CHILDREN'S HOSPITAL OF ORANGE COUNTY

**INTERIOR SIGNAGE &
5 STORY GARAGE SIGNAGE**

Fabrication & Installation - Vomar Products, Inc.

Fabrication Drawing

Sheet Number 18.0

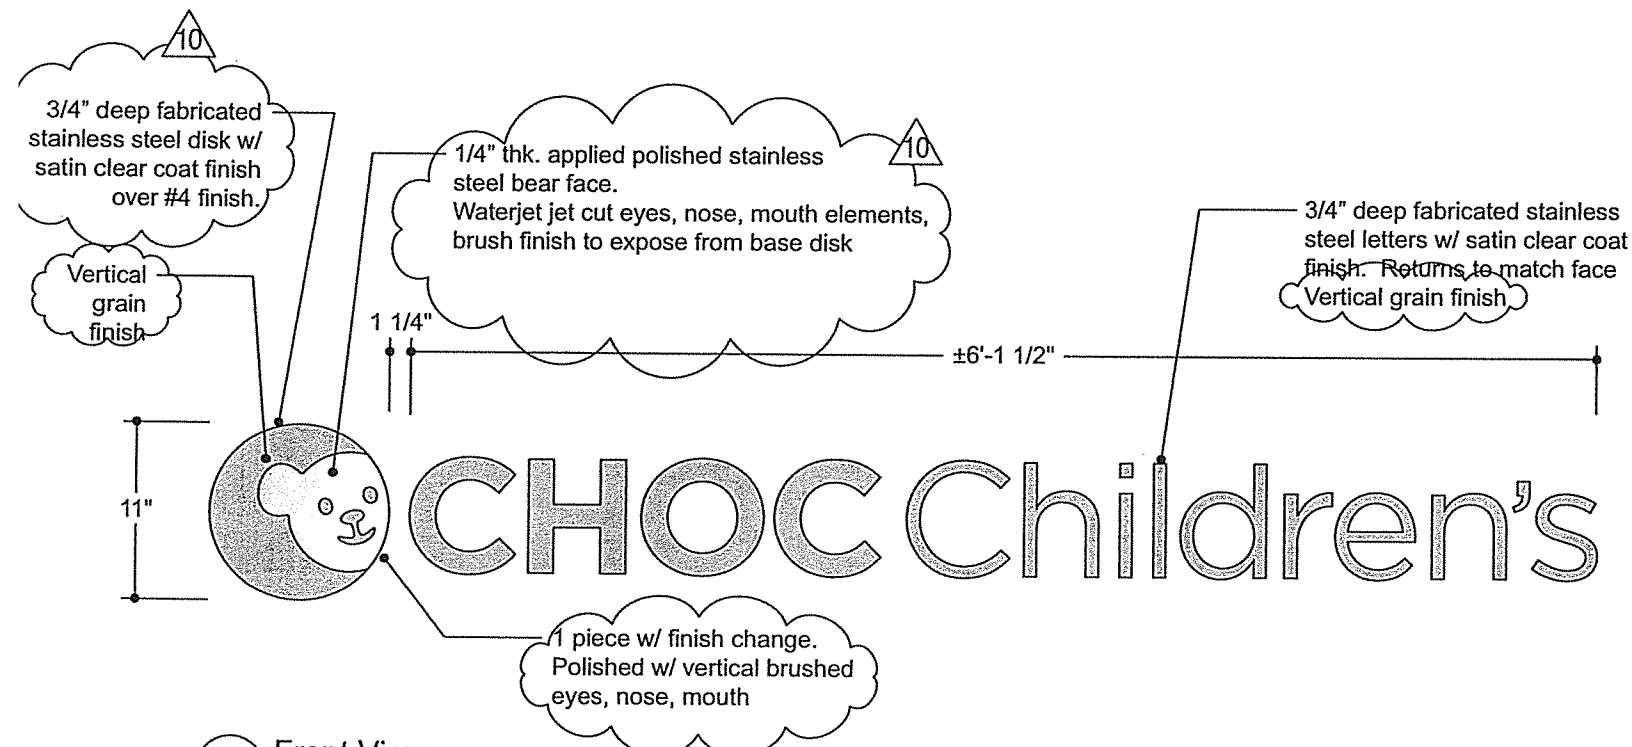
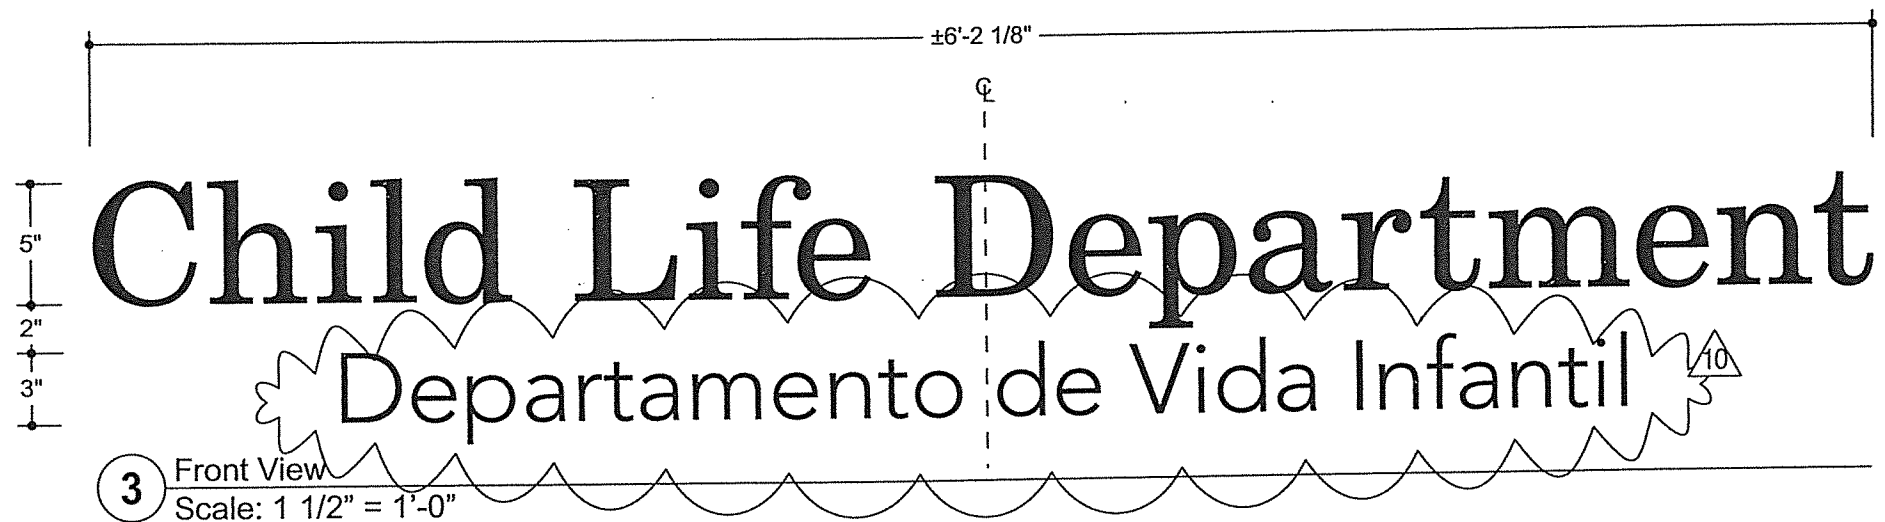
PROVIDE FINISH
SAMPLES FOR REVIEW

11 Location Elevation: Garage North Entrance
Scale: 3/16" = 1'-0"
DIGN

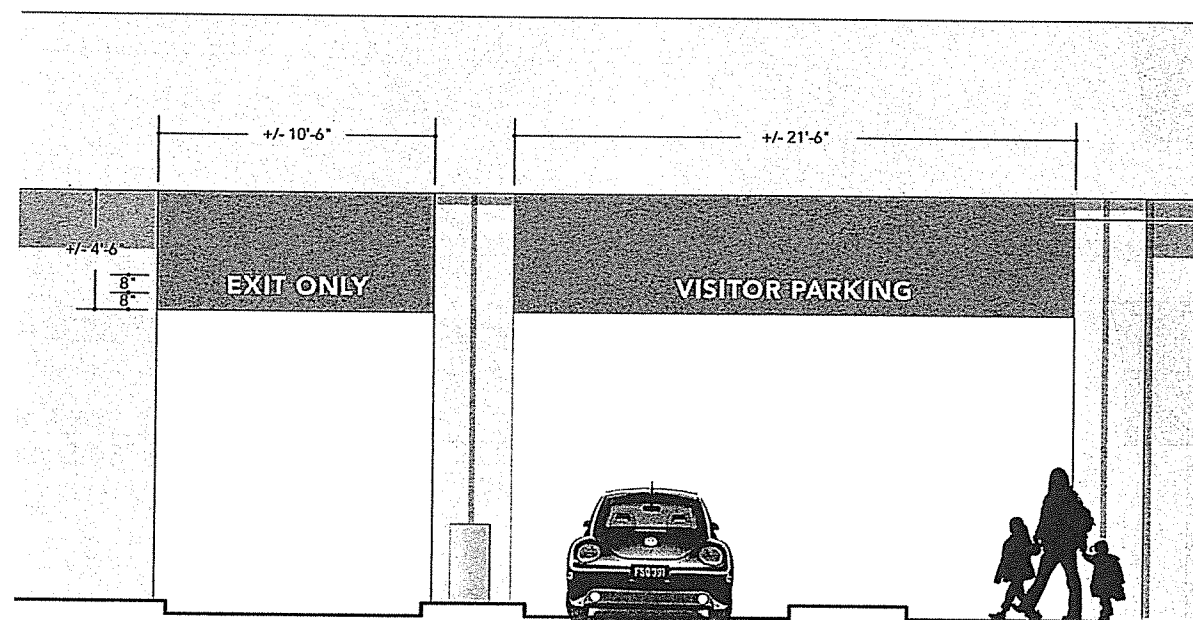
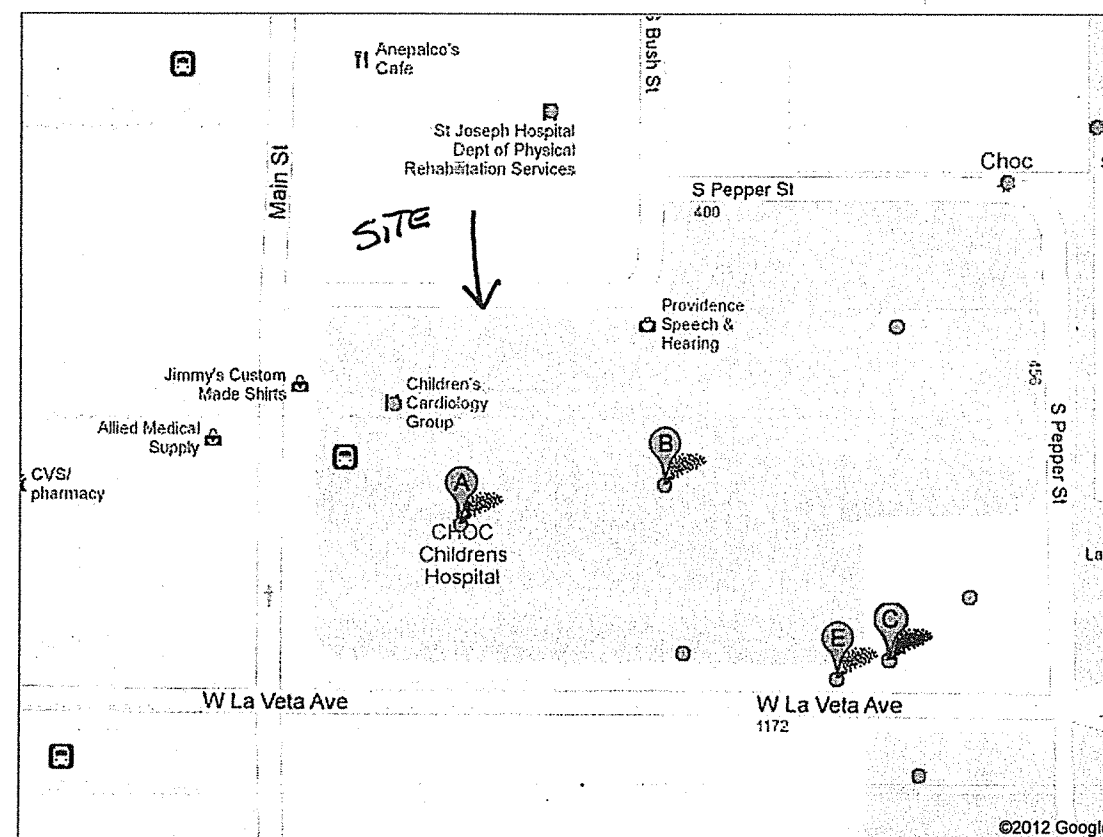
REMOVE AND REPLACE EXISTING BLUE FABRIC ON EXISTING CANOPIES
REPLACE WITH Project "RED" canopy material (see sample color provided)
Material to be "sunbrella" or equivalent
all copy to be white size as shown
Paint existing frame to match red material color

FABRICATOR TO REMOVE AND REPLACE EXISTING BLUE CANOPIES WITH
NEW CANOPIES MATCHING PROJECT "RED". MESSAGES TO BE WHITE.
ALL DIMENSIONS SHOWN ARE APPROXIMATE - FABRICATOR TO FIELD
VERIFY PRIOR TO OUTPUT OF SHOP DRAWINGS.
